September 4, 2003

GASCOLATOR RECALL

This Gascolator Recall notice replaces the Gascolator Required Inspection published in February, 2001 *RVator*. This notice also replaces the GAS-3 Gascolator letter dated June 8, 2001.

GASCOLATOR BOWL END VIEW

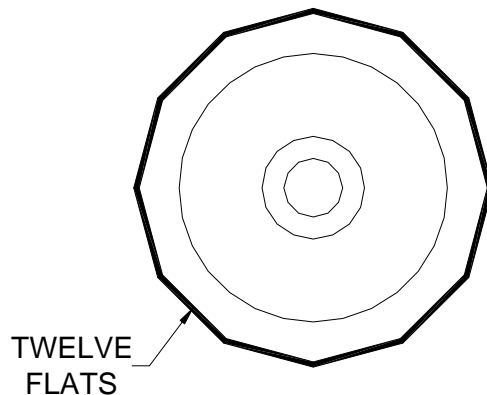
The "OLD STYLE" GAS-3 gascolator bowls differ from "new style" gascolator bowls in the number of flats at the bottom of the bowl. "OLD STYLE" BOWL END CAPS HAVE TEN FLATS. "New style" bowl end caps have twelve flats. Only gascolators with "OLD STYLE" bowl end caps need to be replaced.

OLD STYLE

RETURN TO U.E.I.

NEW STYLE

NOT AFFECTED BY RECALL

If the GAS-3 gascolator has not been installed, then the complete gascolator assembly should be returned to U.E.I.

If the GAS-3 gascolator is installed on a flying or nearly ready to fly aircraft then only the gascolator bowl should be returned to U.E.I. This is to minimize disruption to those pilot/owners with affected gascolator bowls.
